Addendum

Global technical regulation No. 4

Amendment x

(Test procedure for heavy duty hybrid vehicles/engines)

3. Test Procedure for Internal resistance • Open Voltage of Ni-MH / Li-ion Battery for HILS System

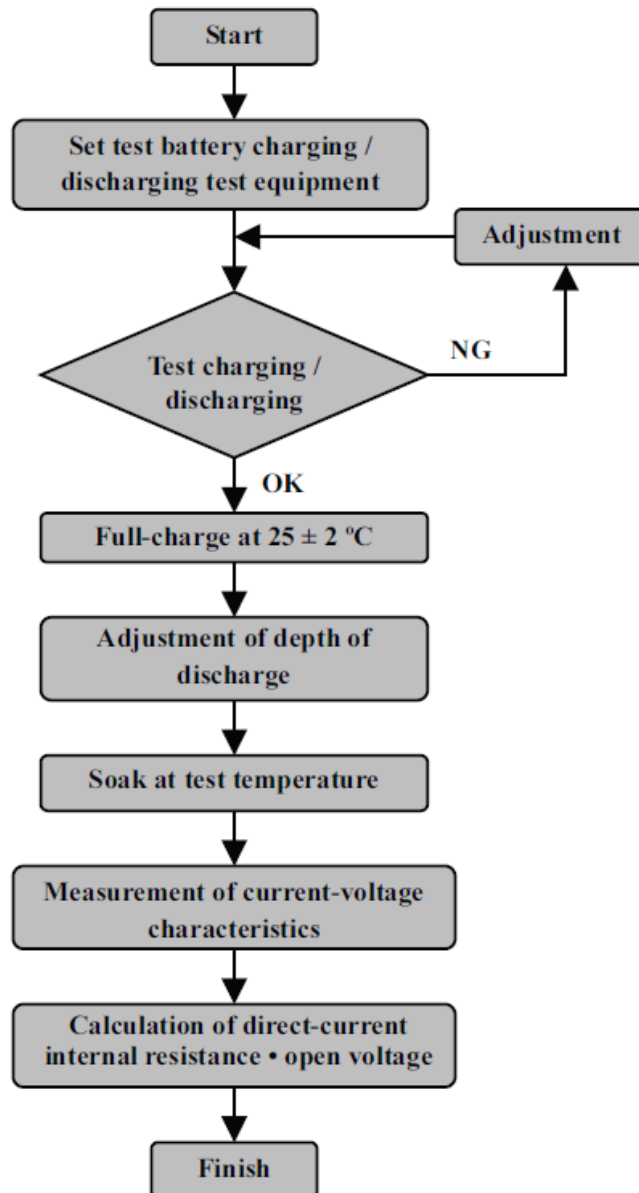
As the input parameters for the HILS system, the direct-current internal resistance - open voltage of the battery shall be obtained. The test method shall be as prescribed and schematically shown below (does scheme remain valid?):

Fig. 3 Test Sequence of Current–Voltage Characteristic Test
(Example: When rated capacity is less than 20 Ah)

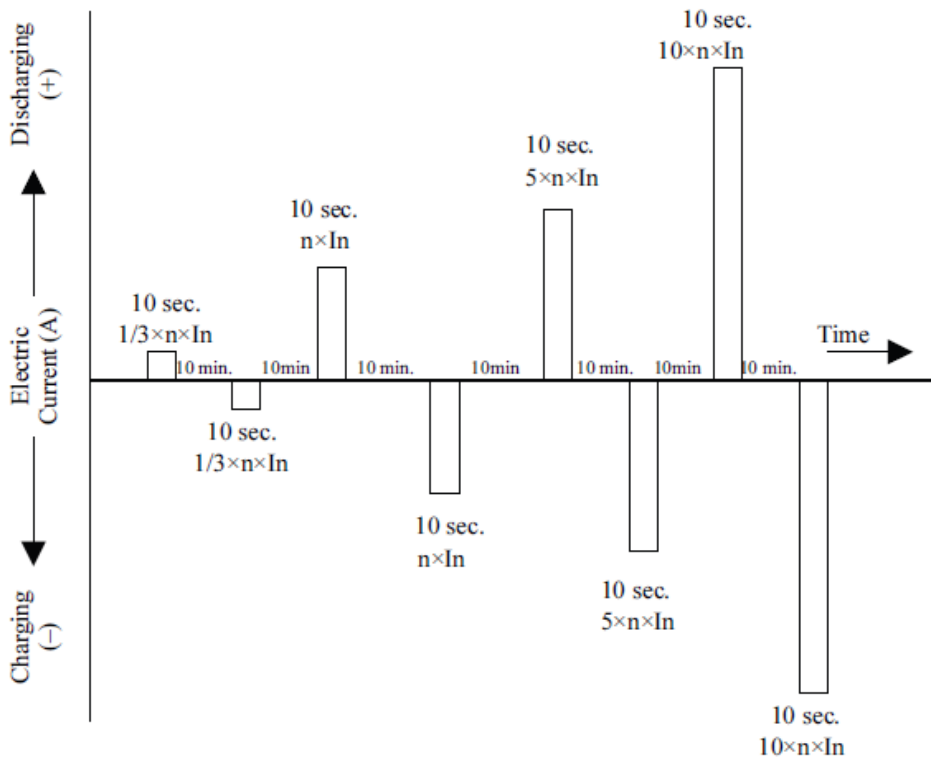
But with altered current (should this be reflect in (1) or (2) already, or only in the figure here?): The highest charge \hat{I}_{charge} and discharge pulse amplitudes $\hat{I}_{\text{discharge}}$ shall be the maximum pulse amplitudes of the in-vehicle use of the storage. The smaller pulses shall be calculated from this maximum values by successively dividing it by a factor of three for three times (e.g. $\hat{I}_{\text{charge}} = 27\text{A}$ gives a sequence for the charge current pulses of 1, 3, 9 and 27A).
